CITY OF MADISON

PLAN OF PROPOSED IMPROVEMENT

N FRANKLIN AVENUE & LYNN TERRACE - ASSESSMENT DISTRICT 2025

CITY PROJECT NO. 15113
CONTRACT NO. 8766

15113		MADISON, WI		CONTRACT NO: 8766		PD-5	
PLAN DETAILS - N FRANKLIN AVENUE		N FRANKLIN AVENUE & LYNN TERRACE - ASSESSMENT DISTRICT 2025		MADISON, WI		M:\DESIGN\Projects\15113\CAD\Streets\15113ENPlanDetails.dwg	
15113		PD-5

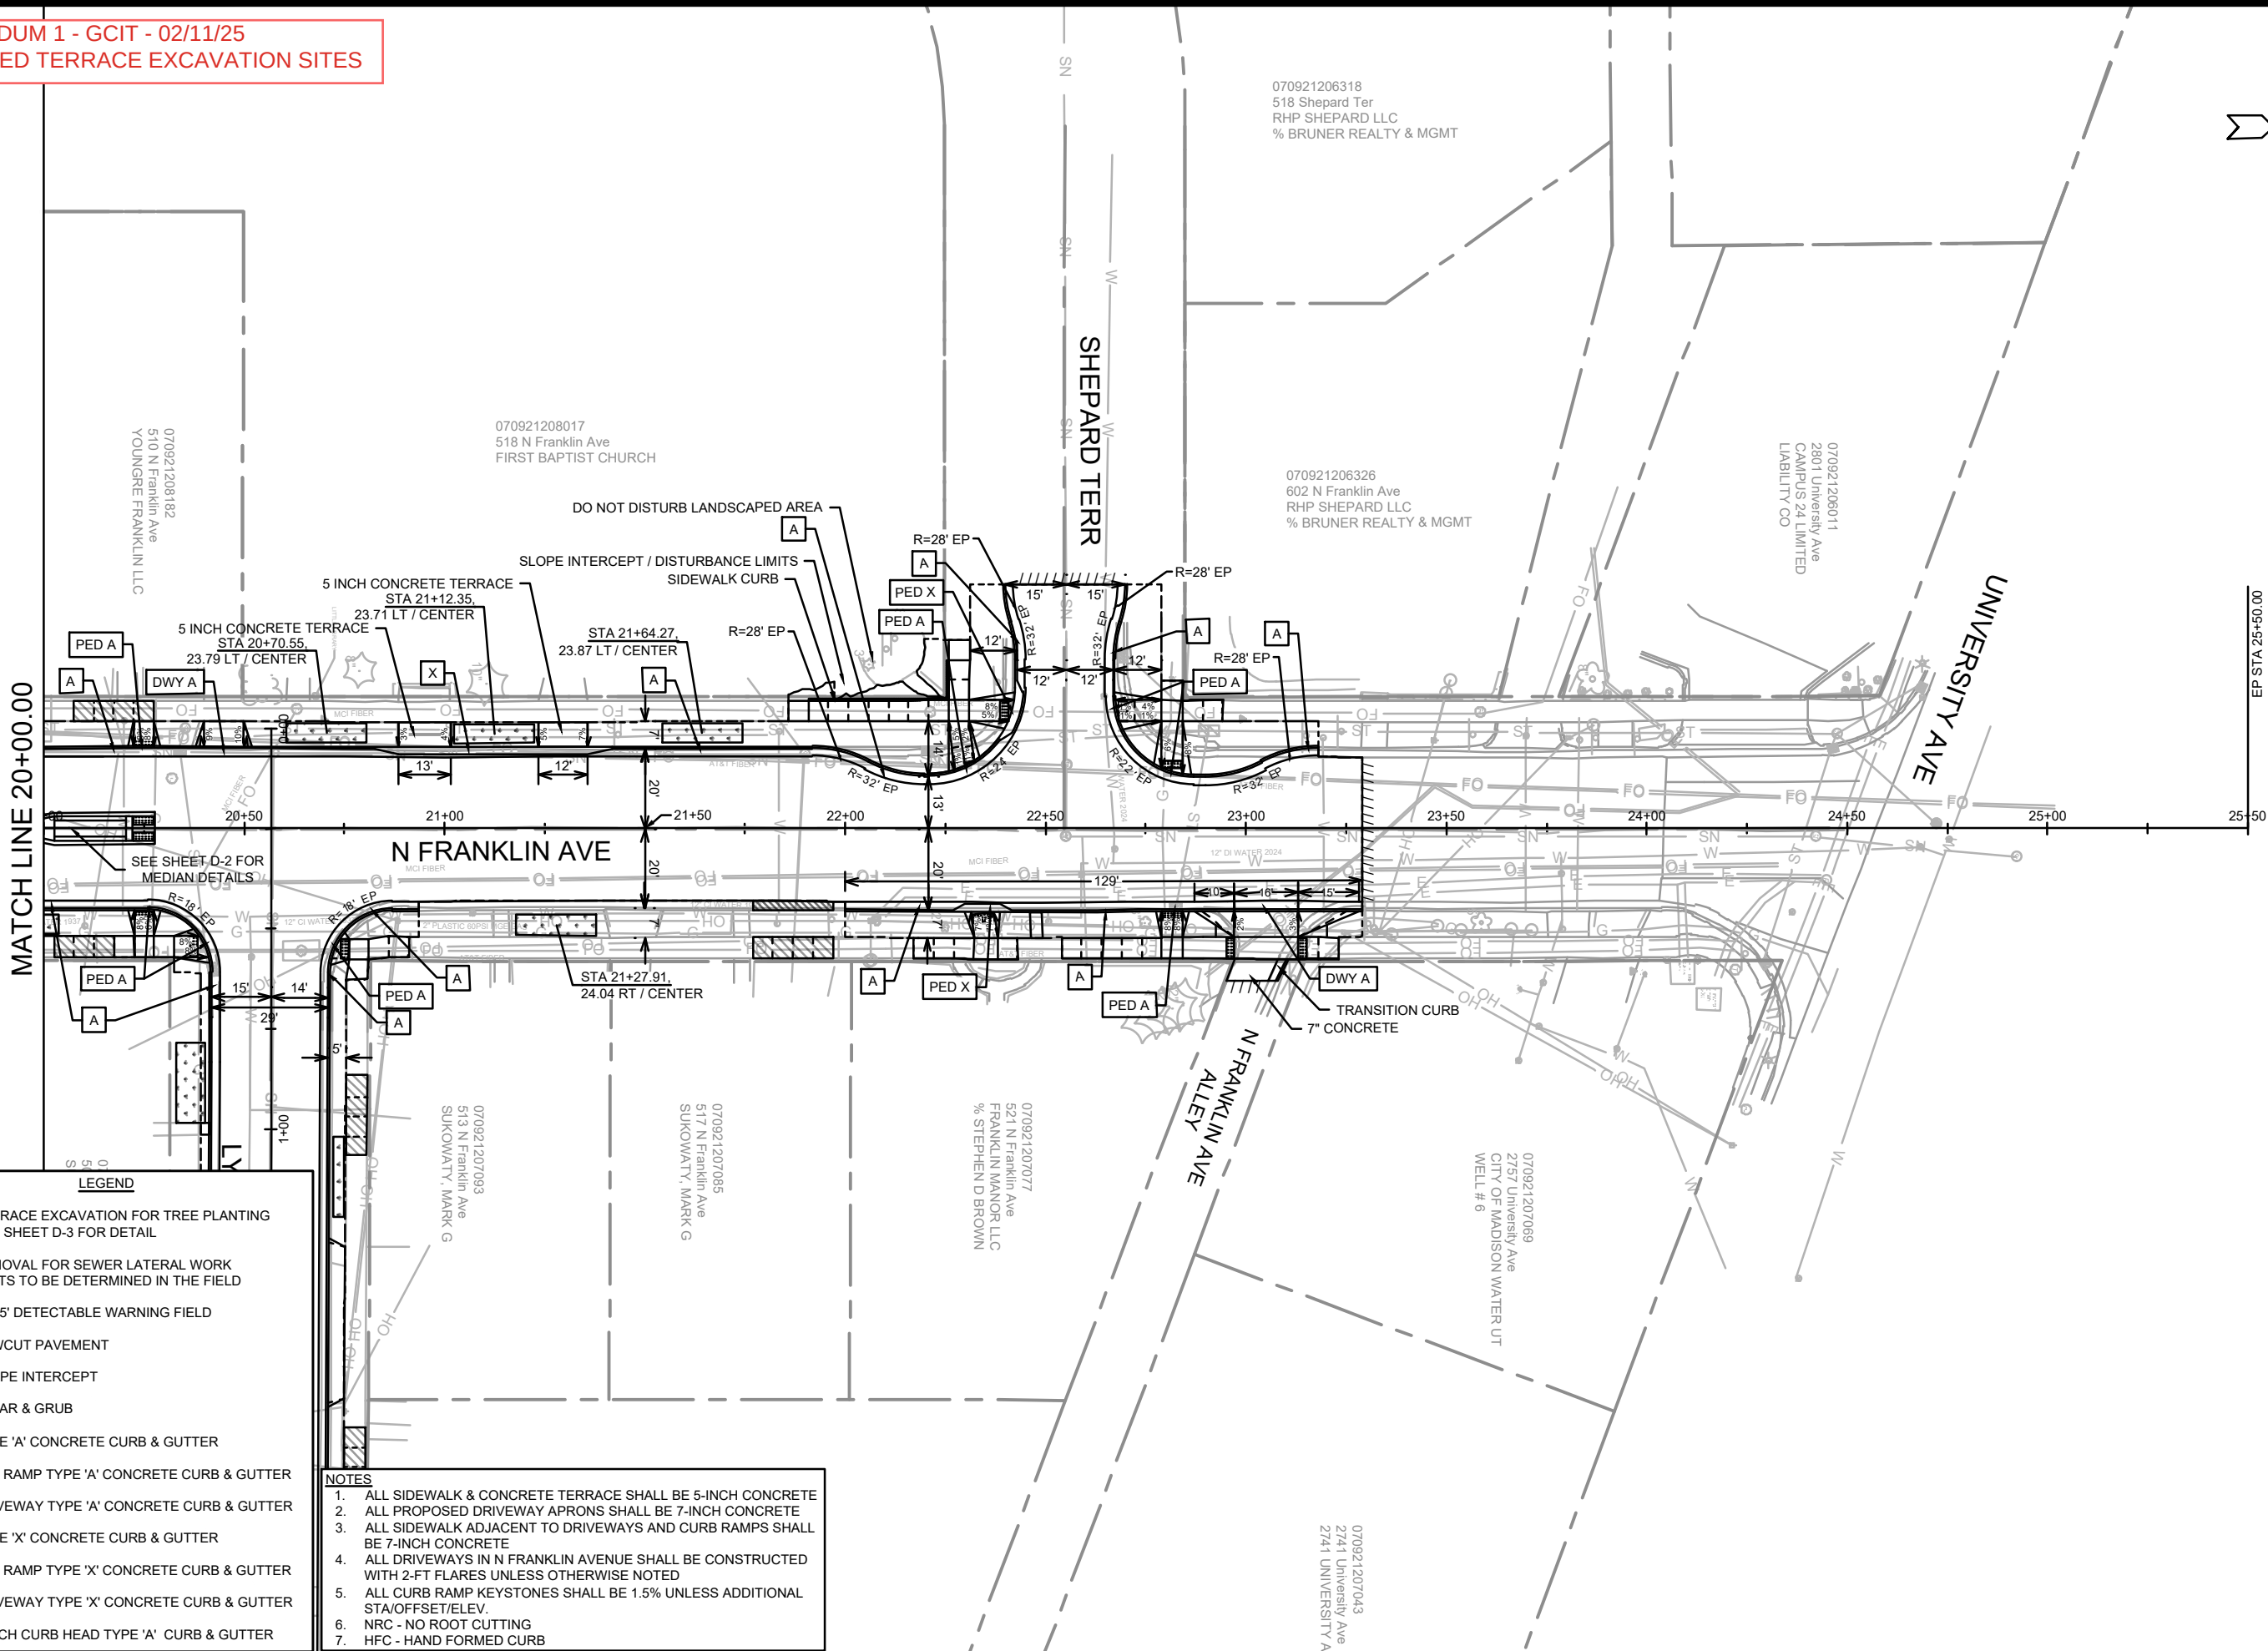
ADDENDUM 1 - GCIT - 02/11/25
- REVISED TERRACE EXCAVATION SITES

N FRANKLIN AVENUE PLAN & PROFILE

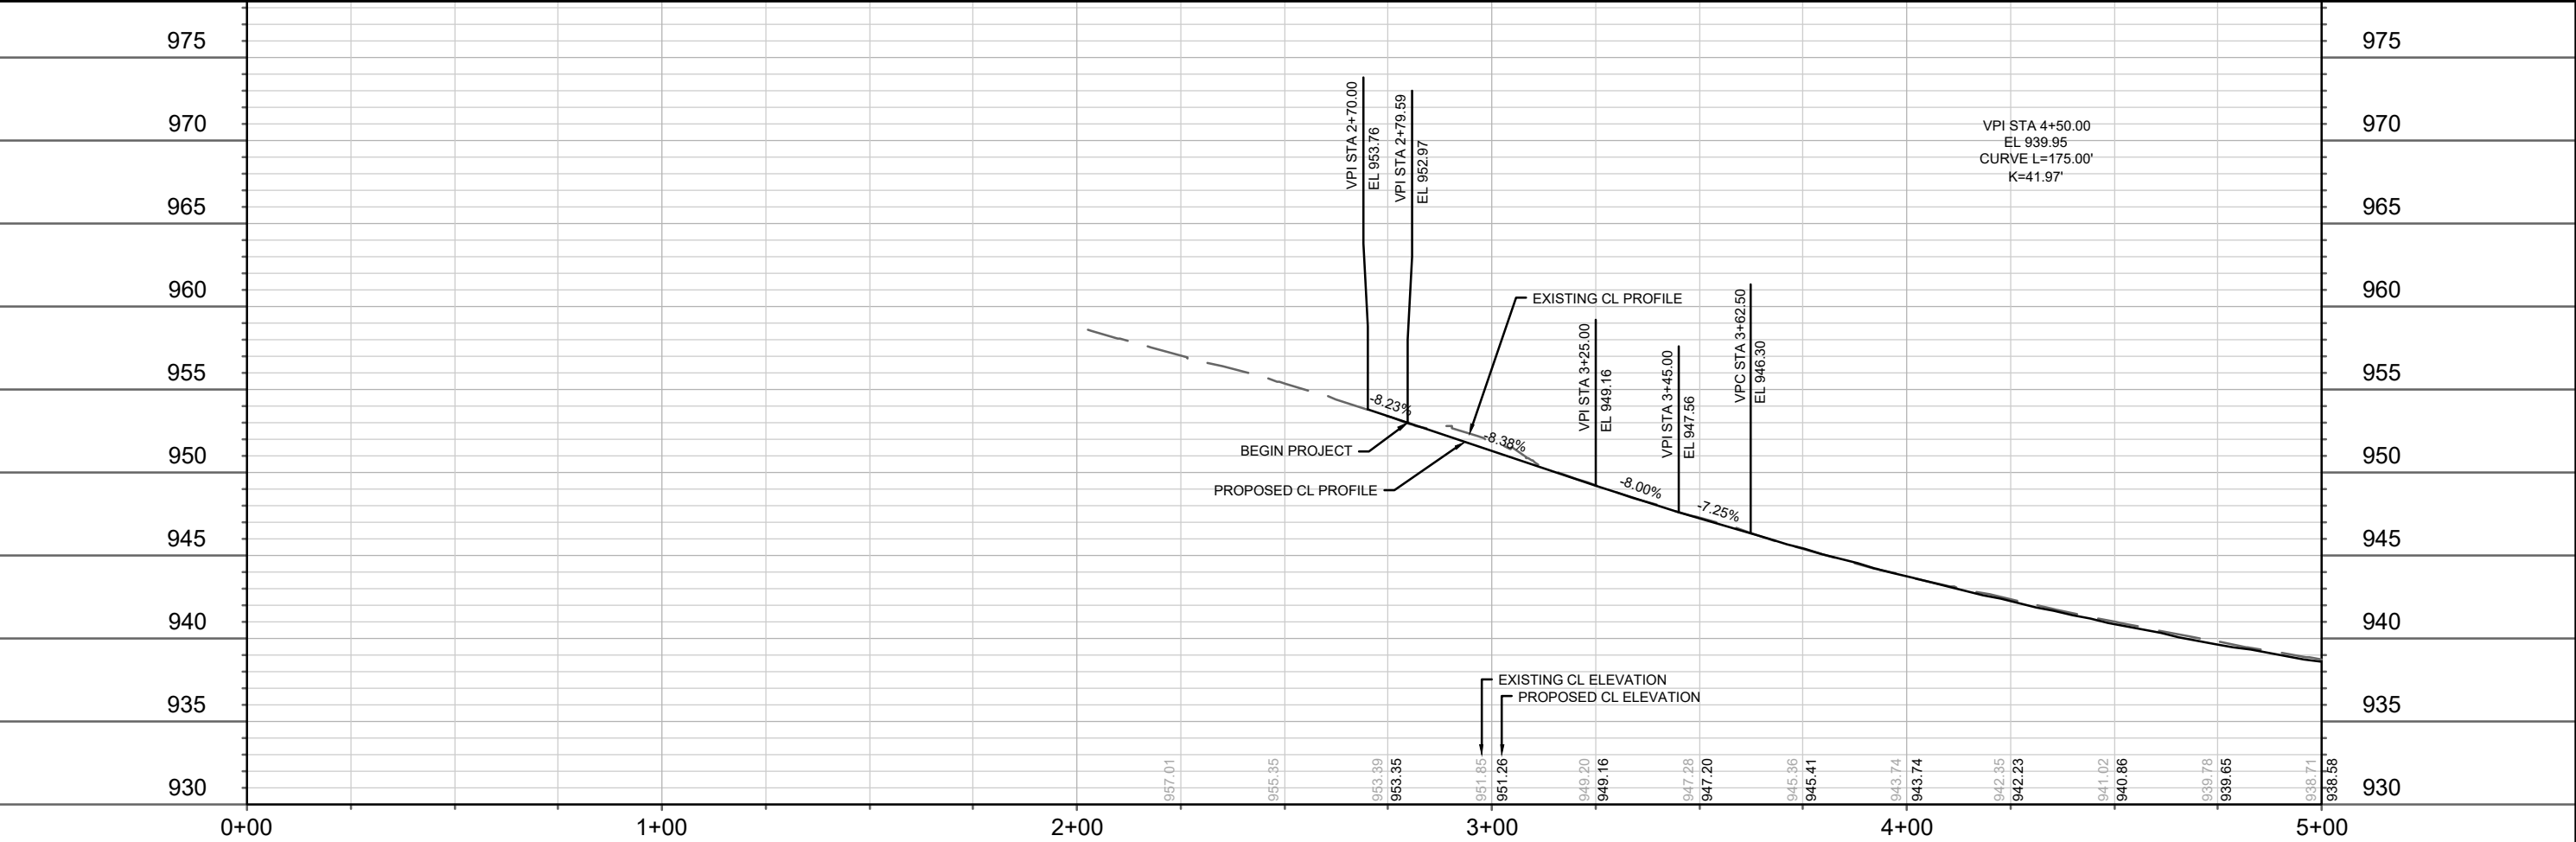
ADDENDUM 1 - GCIT - 02/11/2025
- UPDATED CL PROFILE

REVISION 1 - GCIT - 04/03/2025
- REPRINTED TO SHOW UPDATED
UNDERGROUND UTILITY LOCATION

15113		MADISON, WI		CONTRACT NO: 8766	
N FRANKLIN AVENUE PLAN & PROFILE		N FRANKLIN AVENUE & LYNN TERRACE - ASSESSMENT DISTRICT 2025		M:\DESIGN\Projects\15113\CAD\Streets\15113EN-PnP.dwg	
15113		P-2		15113

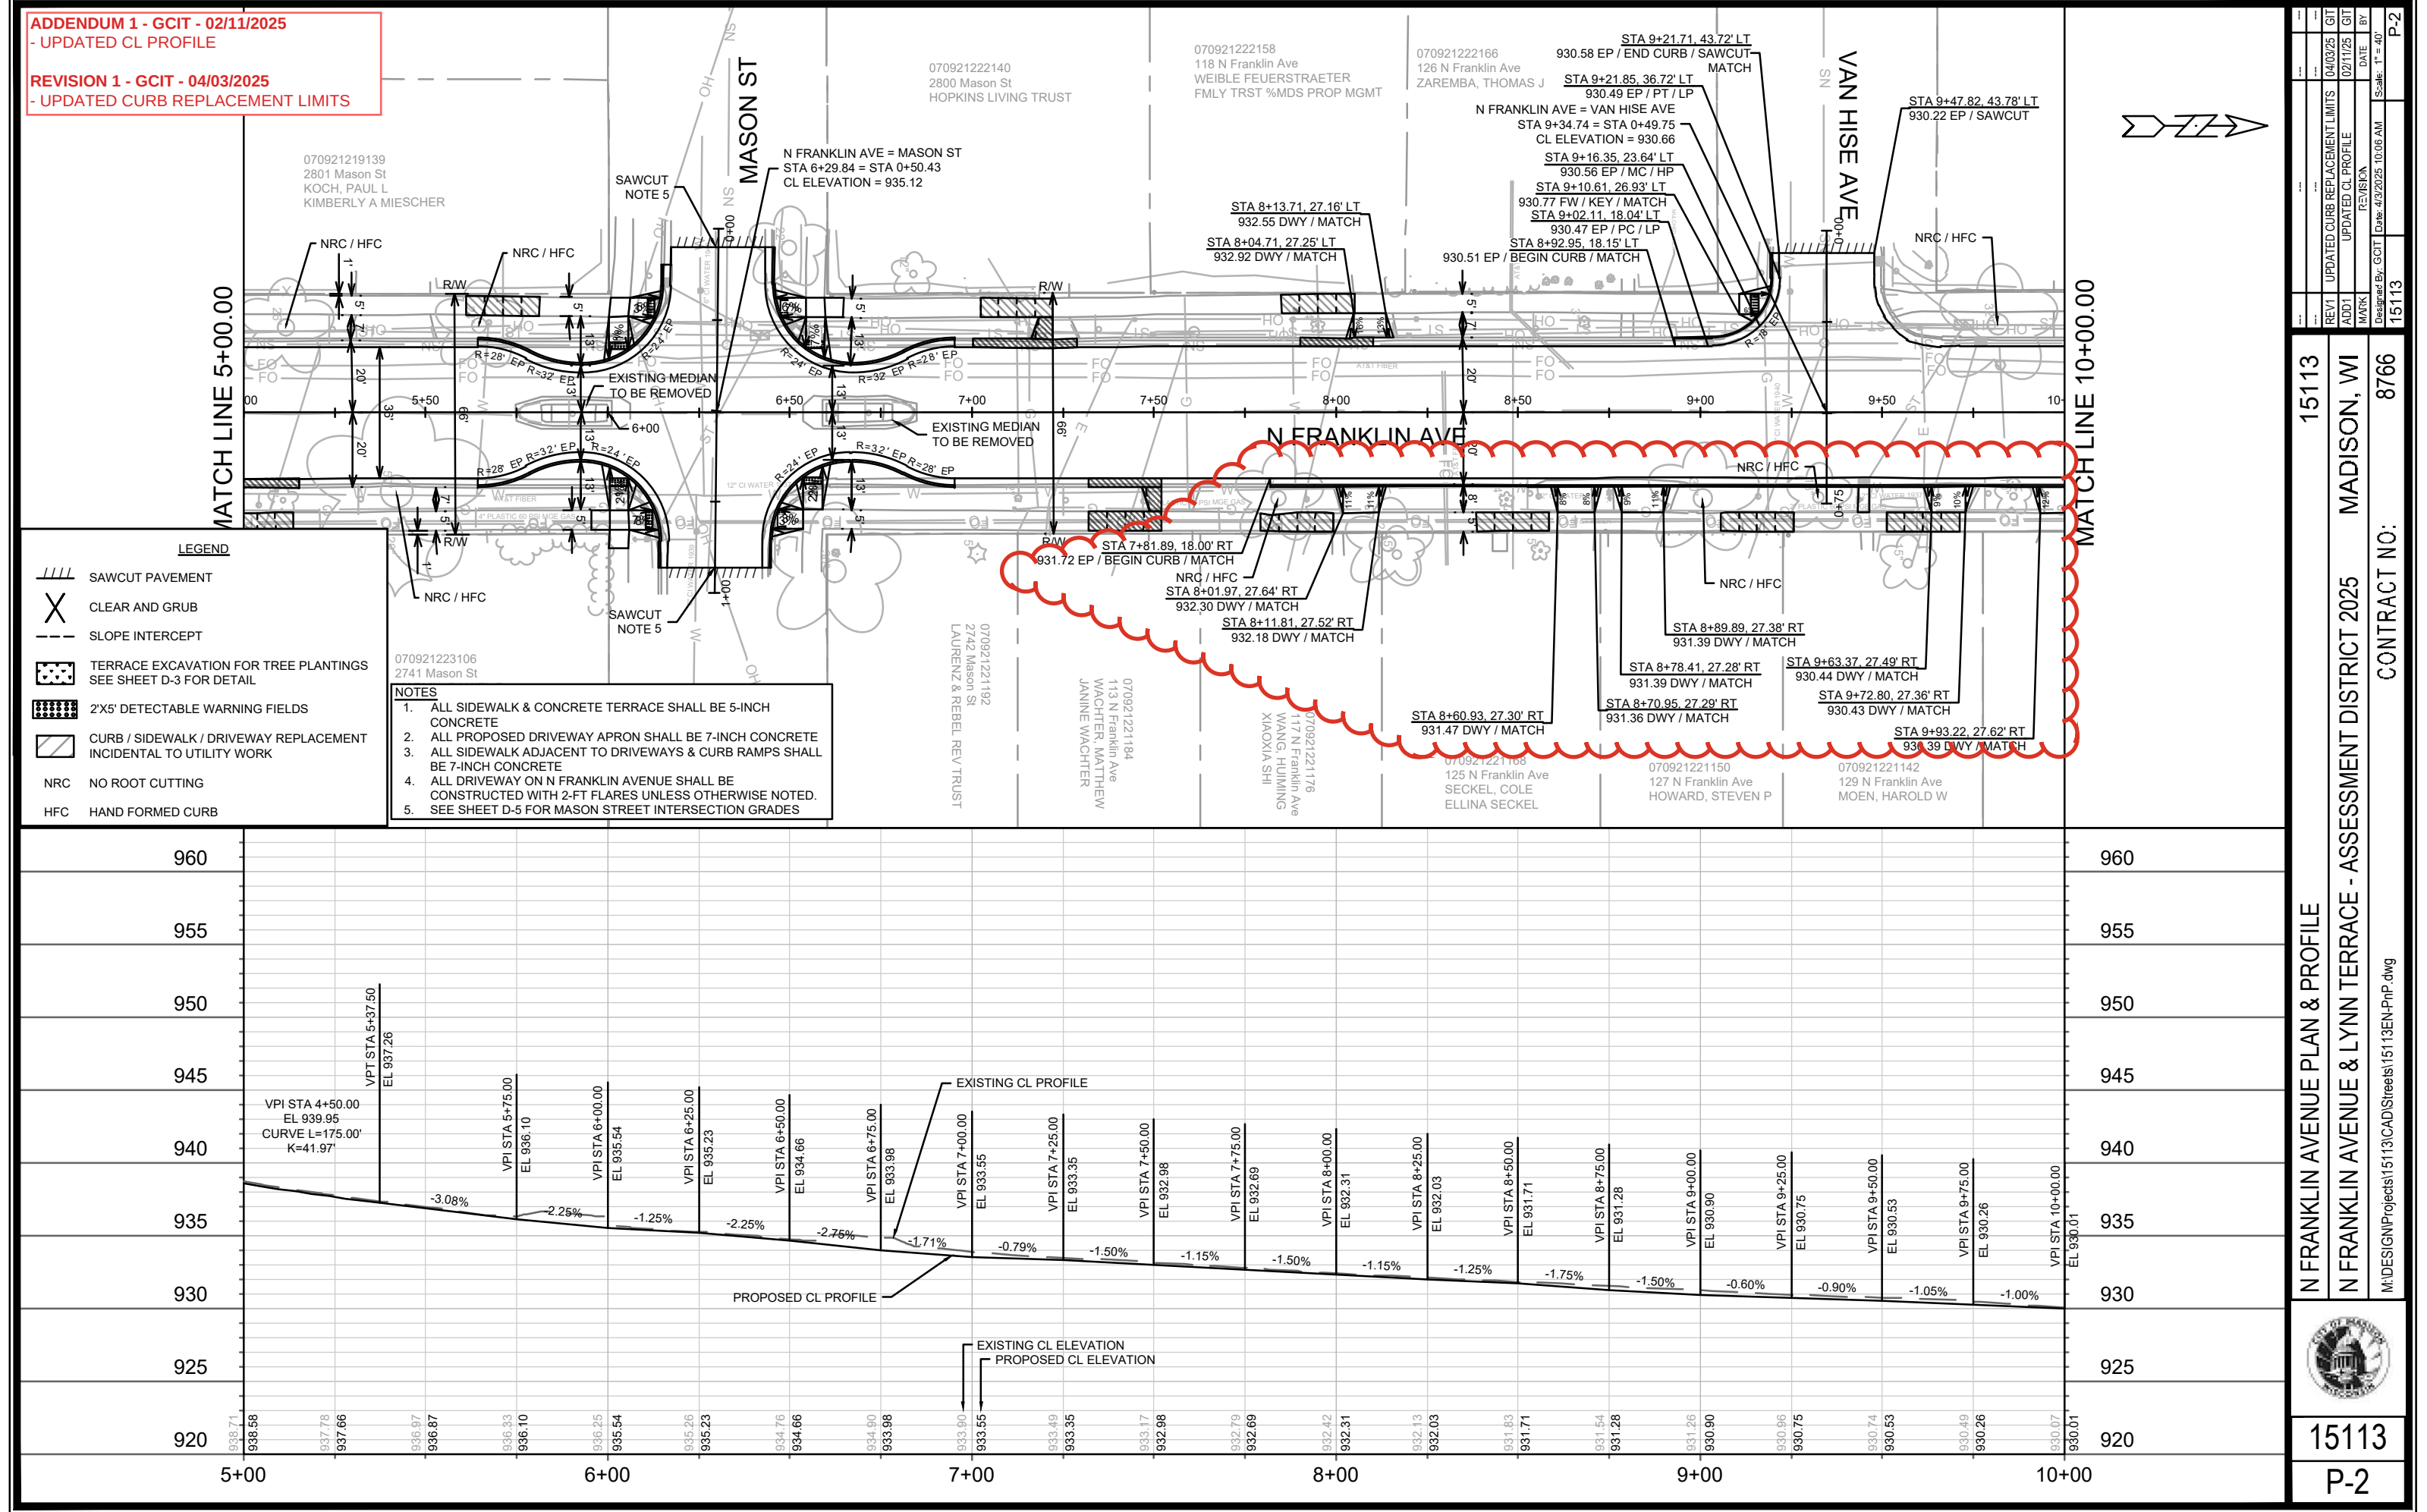
ADDENDUM 1 - GCIT - 02/11/2025
- UPDATED CL PROFILE

REVISION 1 - GCIT - 04/03/2025
- UPDATED CURB REPLACEMENT LIMITS
